Please find a submission for DA 2021/0178

I make a submission to application MOD2021/0178 and amended plans referred to in the letter from council dated 21/10/2021

The picture below shows the roof top plan that was submitted back on 8/9/2021

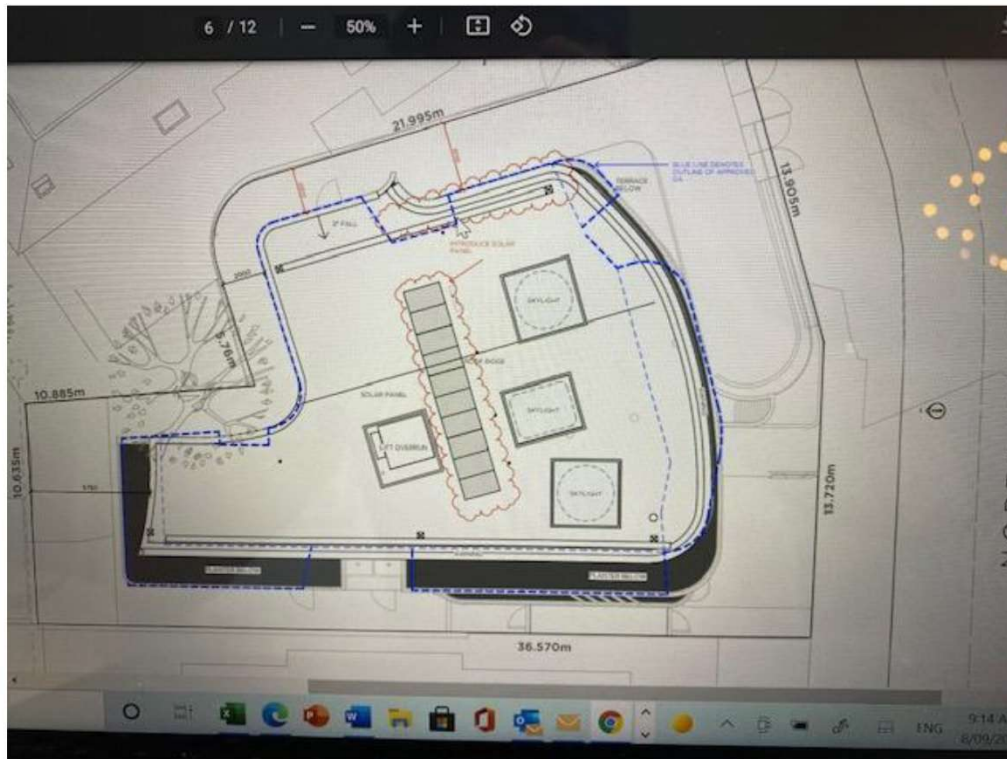
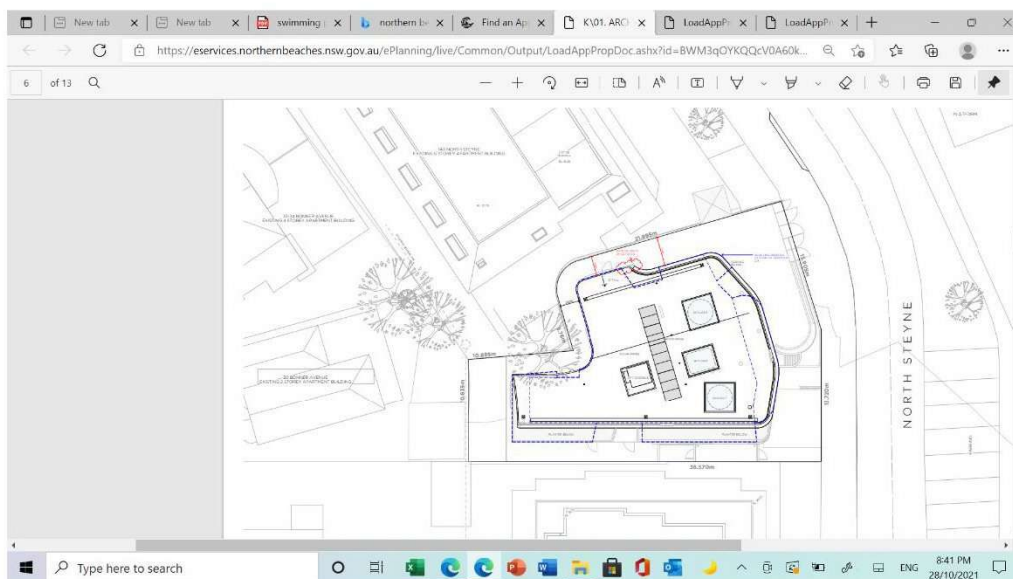
None of the issues I have raised in previous submission relating to lift over run, solar panels and bulk created by extension of the ground floor apartment have been addressed in the so called amended plans .

The solar panel should be moved toward the rear of the roof on the other side of the lift over run.

The applicant has not address where satellite dishes will be placed on the roof or where air conditioning units will be placed.

I cannot seem to find any changes to the roof top design or address any issues of mine .

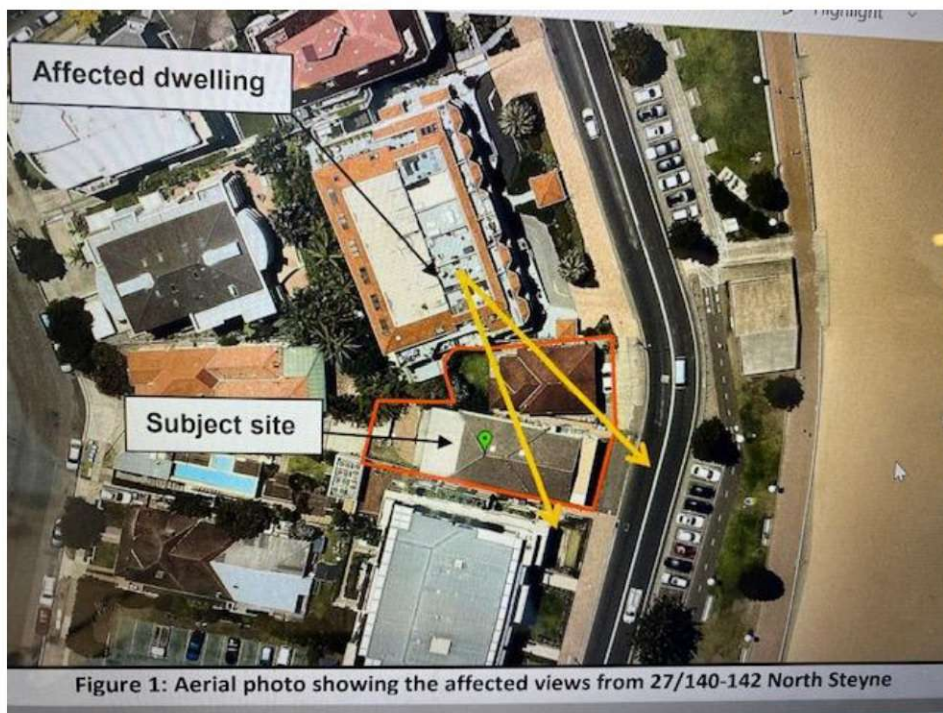
It has not addressed plant and equipment to be moved to the rear of the property .

I have included here an excerpt from my previous submission:

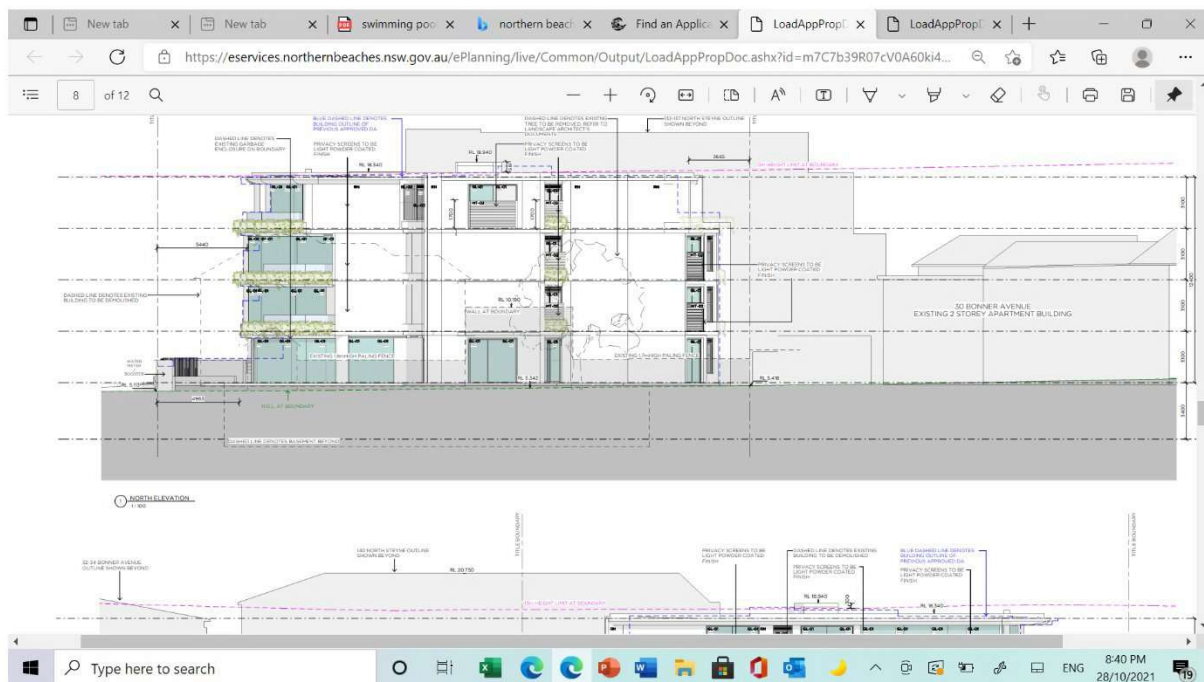
“ Existing views towards Manly Beach and the headland from the upper terrace of 27/140-142 North Steyne are show above In addition, such services as air-conditioning equipment, satellite dishes etc. have not been shown on the roof plan. It is likely that this equipment would also create an eyesore for residents of the upper-level apartments within the development to the north. Section 3.4.3 (Maintenance of Views) of the MDCP 2011 requires that disruption to views is minimized from adjacent development. In addition, Roof-top Plant) requires that roof-top mechanical plant equipment including air-conditioning systems must be inconspicuous. proposed development and associated view loss to the south. Therefore, it is requested that a 3D view assessment be carried from the upper terrace of Unit 27 and 28/140-142 North Steyne which shows the proposed equipment located on the roof level. Furthermore, to minimize visual and acoustic impacts associated with such equipment, as well as any potential glare or reflectivity nuisance associated with the solar panels, it is requested that the photovoltaic cells, plant and services equipment be relocated to the rear of the roof, so as to minimize disruption of views from the upper level terraces of 140-142 North Steyne. Such outcome would be consistent with the Planning Principle under Tenacity Consulting v Warringah Council as relocation of the rooftop services, which would minimize view impacts with represent a more skilful design and would not be detrimental to the views afforded to the proposed “
